GFA AIRWORTHINESS DIRECTIVE

TYPE AFFECTED: Krosno KR-03A Puchatek, serial numbers 03-01 to 03-24 and 04-01 to 04-20.

SUBJECT: Visual inspection of tailplane (horizontal stabilizer) attachment fitting.

2002-16-17 Barry Aviation, LLC: Amendment 39-12856; Docket No. 2002-CE-30-AD.

Figure 1. **Part No. NS-03/08/93-01 L/P**

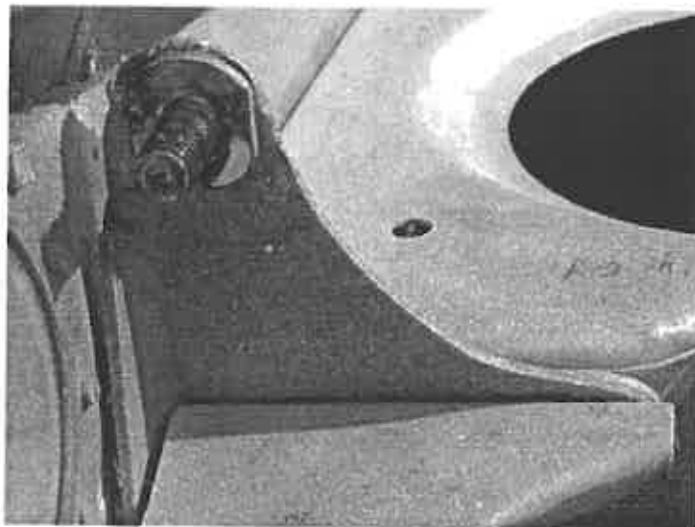
This is the component that **should be** installed on the Krosno KR-03A sailplane. It can be identified by measuring the material thickness in Fig. 1 and verifying a measurement of 3 mm.

A visual inspection of the Horizontal Attachment Fittings is required to determine if your sailplane has the correct Attachment Fittings No. NS-03/08/93-L/P. These parts have a 3 mm thickness in specific areas versus the older 1.5 mm part. (See attached drawings to identify correct fittings.)

Figure 2. **Part No. AB.14.004.00.11/21**

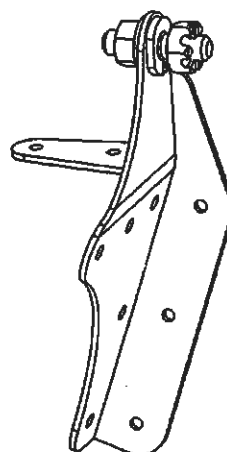
This is the component that **may be** installed on the Krosno KR-03A sailplane. It can be identified by measuring the material thickness in Fig. 2 and verifying a measurement of 1.5 mm. If this component is installed on the Krosno KR-03A, follow the instructions contained in **WSK "PZL-KROSNO" Service Bulletin BE-29/KR-03A/93.**

2. If an incorrect fitting has been installed, replacement of the stabilizer attachment fittings is required before the next flight. Follow the KROSNO Service Bulletin BE-29/KR-03A/93. Notify Barry Aviation LLC, of your findings, with the serial number and time in service for sailplane and current owner/operator contact information. This will permit us to update our records and provide timely communication and product support. For your convenience, you can provide this information over our web site www.barryavation.com. Please specify your preference for shipping with specific instructions for replacement parts. Make an appropriate entry in sailplane's permanent record and return to service.
